EPA Region 8
Underground Injection Control (UIC) Program
Response to Public Comments

Class III Area Permit No. SD31231-00000, Aquifer Exemption Decision
And
Class V Area Permit No. SD52173-00000

Powertech (USA) Inc.
P.O. Box 448
Edgemont, South Dakota 57735

Final Permit issuance: November 24, 2020

Figure T. Pass Creek alluvium cross-section and the Burdock Area Pond locations for the Class V disposal option.

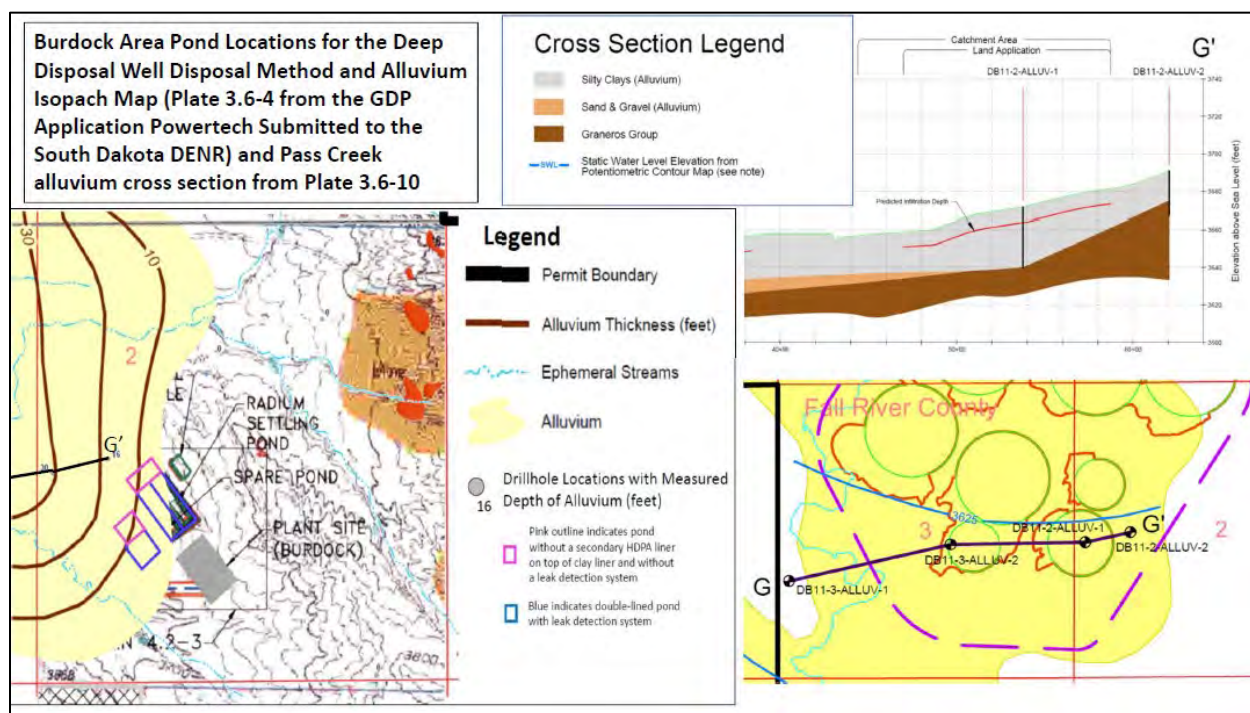
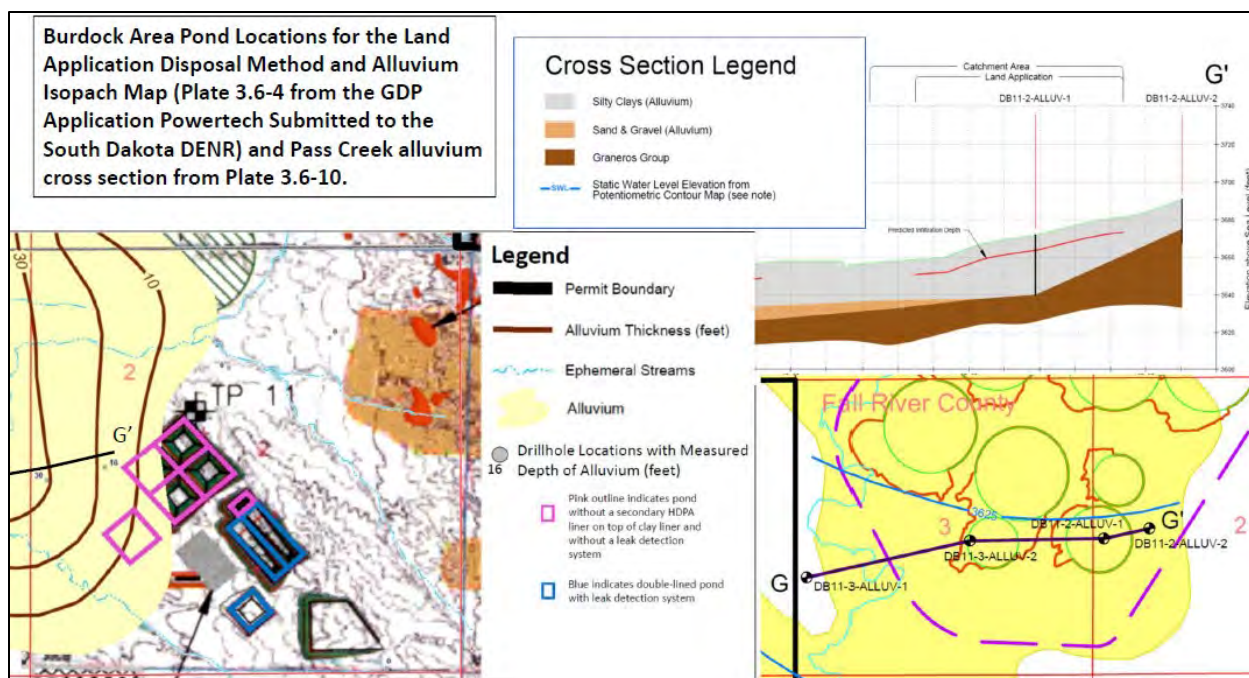
EPA does not agree with Powertech about the potential impacts from a pond leak in this area. EPA performed an analysis of the geological conditions underlying the Burdock Area Ponds to evaluate impacts from the potential leaking of ponds. EPA has concerns that although the ISR waste fluids would have been treated to remove radium, the stored water would still contain byproduct material and high TDS reject water from the reverse osmosis treatment system. Leaking from ponds in this area have the potential to affect alluvial aquifers. Plate 3.6-10 in the Groundwater Discharge Permit Application shows cross-sections of the Pass Creek alluvium and Appendix 3.6-A contains logs from Pass Creek alluvial

Because of EPA's concern about potential effects to these alluvial aquifers, EPA included a condition in Part II, Section I.4.a of the Class III Area Permit requiring the Permittee to submit information to the EPA Region 8 Air and Radiation Division to determine the applicability of the 40 CFR part 61, subpart W regulations, and if necessary, receive construction approval from EPA. If CAA subpart W applies to these ponds, Powertech will need to meet subpart W requirements. The surface impoundment design, construction, and operating requirements are found under 40 CFR § 264.221(c) which requires two or more liners, installation of a leak detection system, and a leachate collection and removal system between such liners.

Figure V. Burdock Area Land Application Area and proposed Perimeter of Operational Pollution (Sources: Groundwater Discharge Permit application Figure 6.1-3 and Class III Permit Application Plate 6.12)

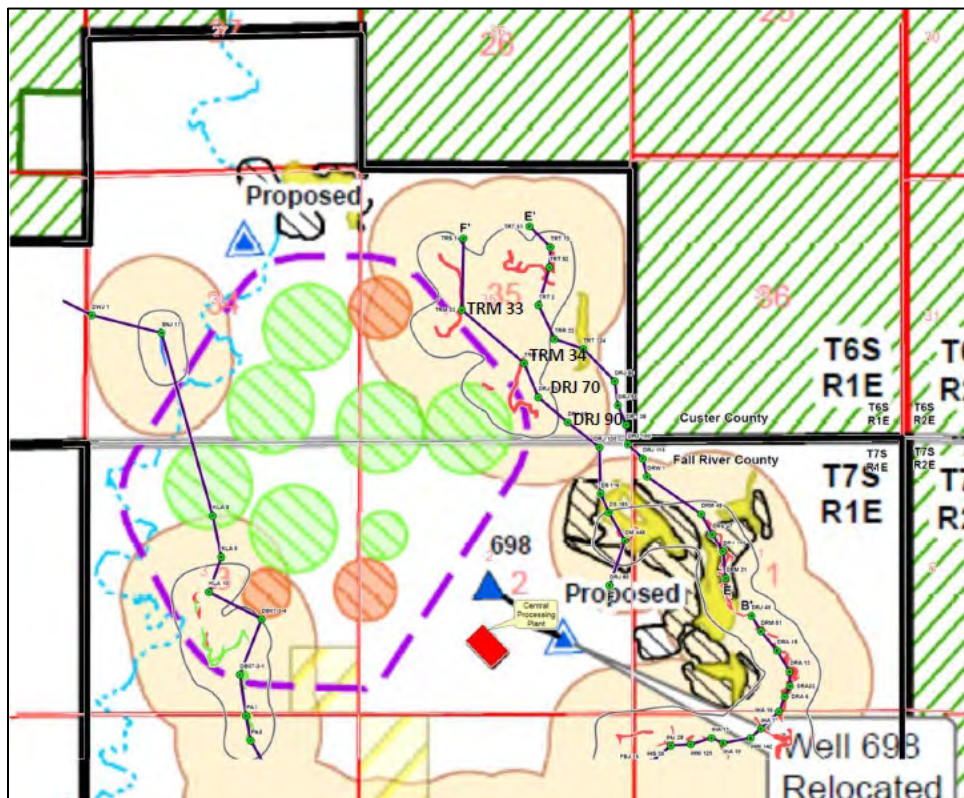
EPA reviewed drillhole data along northeastern POP boundary in the Burdock Area. Figure V shows the Burdock POP boundary from Groundwater Discharge Permit application. Figure 6.1-3 contains an excerpt from Plate 6.12 of the Class III Permit Application showing available cross-sections in the Dewey-Burdock Area. According to Class III Permit Application Plate 6.18 Cross-Section F-F', logs of drillholes TRM 33 and TRM 34 show 10 feet of Graneros Shale. Because the Graneros Shale has been eroded away in this area, logs of drillholes DRJ 70 and DRJ 90 show the Graneros Shale is absent above the Fall River Formation. Because these drillhole locations are located outside the POP boundary, they do not necessarily indicate the Graneros is less than 25 feet thick within the land application areas. Groundwater Discharge Permit application Plates 3.6-9 Cross-Section E-E' and Plate 3.6-8 Section D-D' show that the Graneros shale is 25 feet or more within the land application areas. Cross-Section F-F' in Plate 6.12 of the Class III Permit Application also shows that the Upper Fall River is not saturated at the locations of drillholes TRM 34, DRJ 70 and DRJ 90. Powertech proposes vadose zone monitoring at catchment areas (which are shown in Figures 6.1-2). EPA considered whether monitoring wells should

be completed in the Fall River aquifer at the northeastern POP boundary and determined that the catchment area vadose zone monitoring at the northeastern edges of the Burdock land application area will also serve as monitoring for the Fall River aquifer in this area. In addition, the Upper Fall River aquifer monitoring wells associated with Burdock Wellfield 8 will also provide monitoring for TDS, specific conductance, and alkalinity at the northeastern POP boundary.

Figure W Projected Construction, Operation and Decommissioning Schedule (Source: Figure 10.2 in the Class III Permit Application.

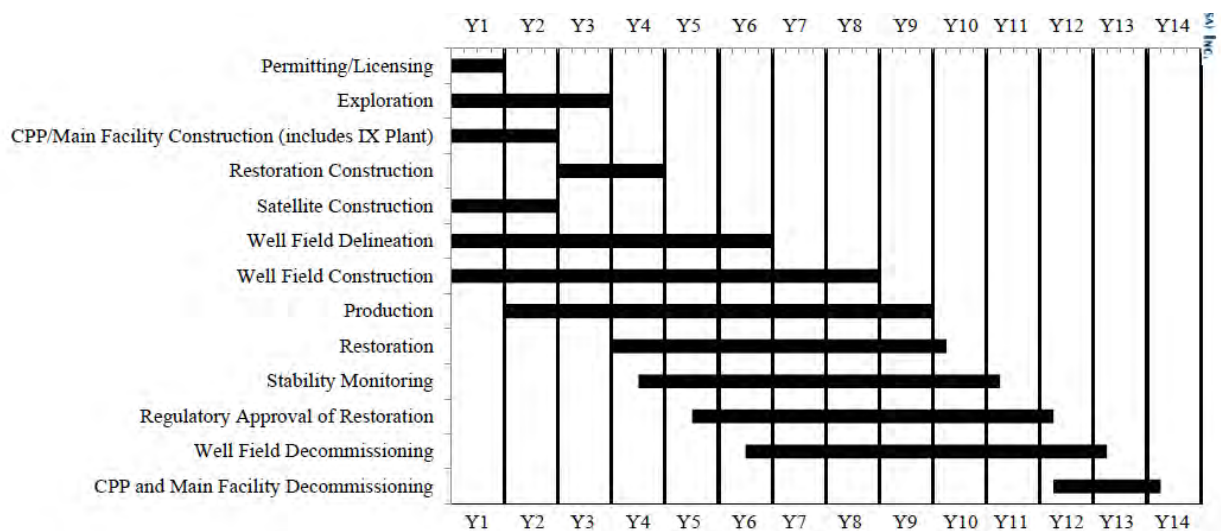
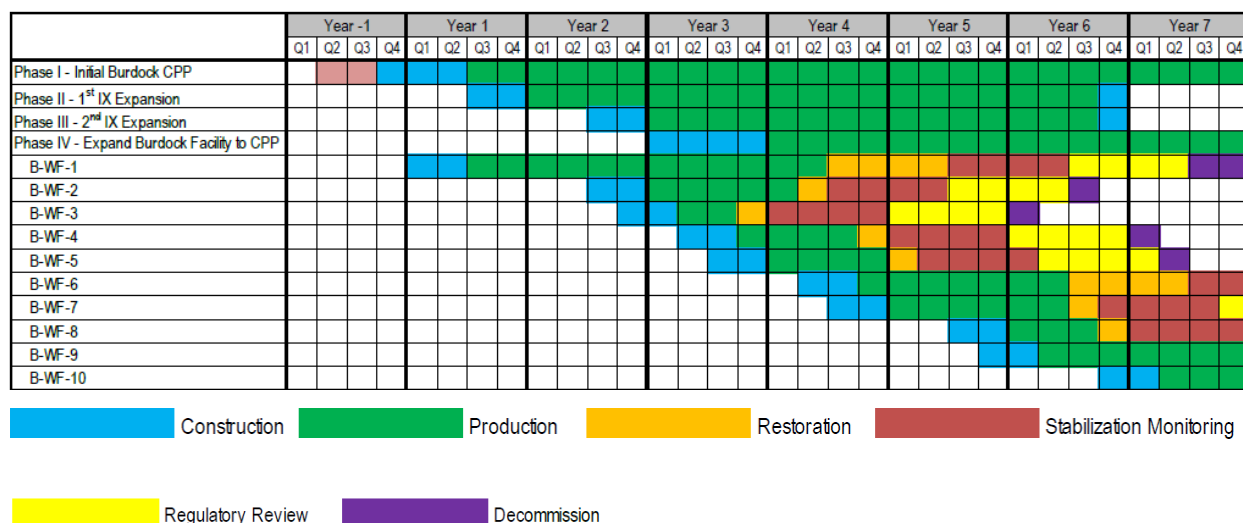
The Class III Permit Application includes the project timeline in Figure W showing an estimated life of the project to be 14 years. Not all 14 wellfields will be in operation at the same time, because Powertech plans to initiate wellfield phases (construction, operation, restoration, closure and decommissioning) sequentially for each wellfield. Figure X shows an example of this sequential approach for Burdock Wellfields 1 through 10.

Although the Class III Area Permit has been issued for the life of the project, if Powertech proposes additional wellfields, the company must apply for a major permit modification, which will trigger an updated CEA that will address additional wellfields and the extended project life. A major permit modification will also require another public comment period. Conducting an analysis before that time would be based on speculation instead of actual data. The Class V Area Permit expires after 10 years. Renewal of the Class V Area Permit will provide another opportunity for public comment and an updated CEA. By the time a Class V permit renewal or Class III permit modification occurs, operational information should be available on the amount of time actually needed for each wellfield phases to better inform the life of the project.

Figure 3.2-6: Overall Process Flow Diagram

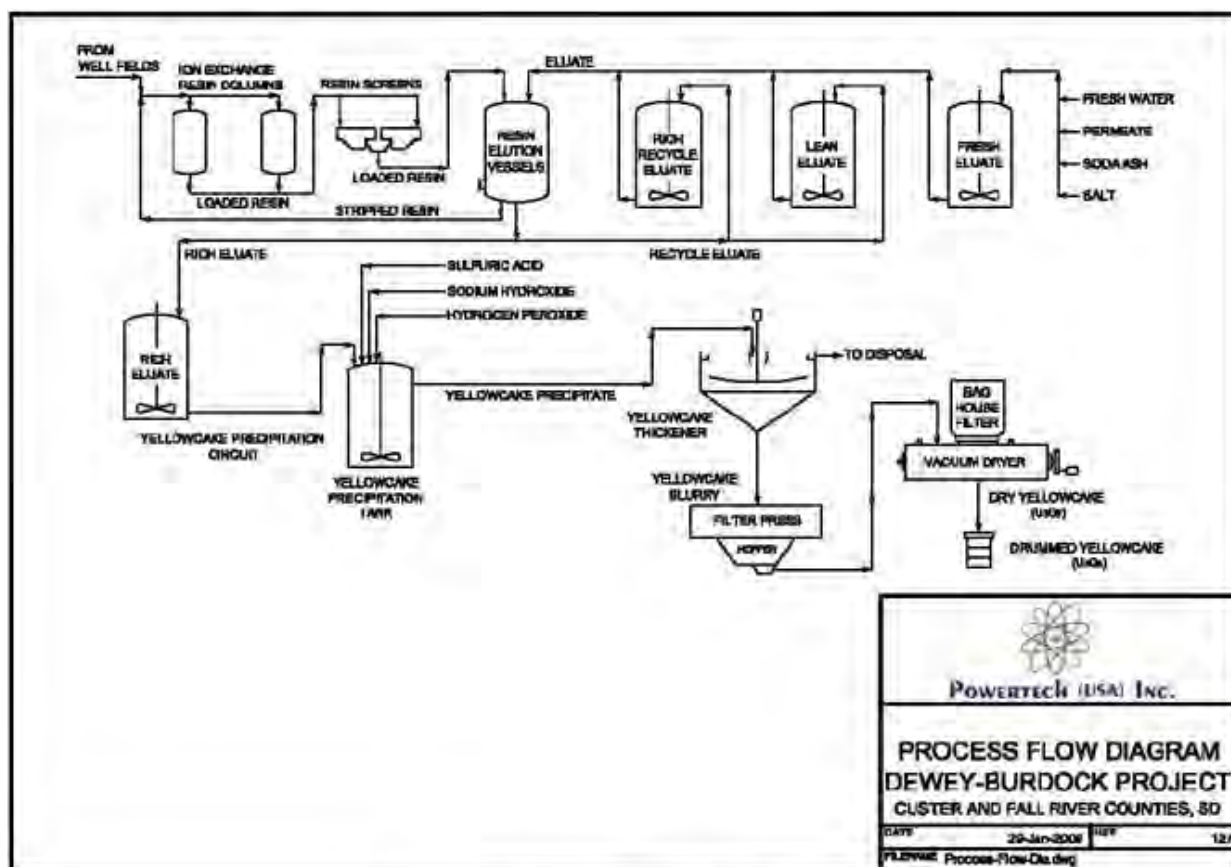
361. Powertech raises a comment regarding the statement in the CEA that Powertech proposes to store, use, and receive shipments of anhydrous ammonia (NH₃). According to Powertech, it does not propose to use ammonia at the Dewey-Burdock Project. Powertech refers to Figure 3.2-6 in the approved NRC license application and explains that it shows that sodium hydroxide will be used in the precipitation circuit instead. Powertech also refers to Table 3.2-1 in the approved NRC license application, which lists the process-related chemicals and quantities planned for the project, likewise does not include ammonia. Powertech requests removing mention of anhydrous ammonia from this paragraph.

EPA agrees with Powertech's comment and has updated the two references to "anhydrous ammonia" (NH₃) in the CEA Section 12.2, and instead replaced them with sodium hydroxide. We have included Figure 3.2-6 in the approved license application here.
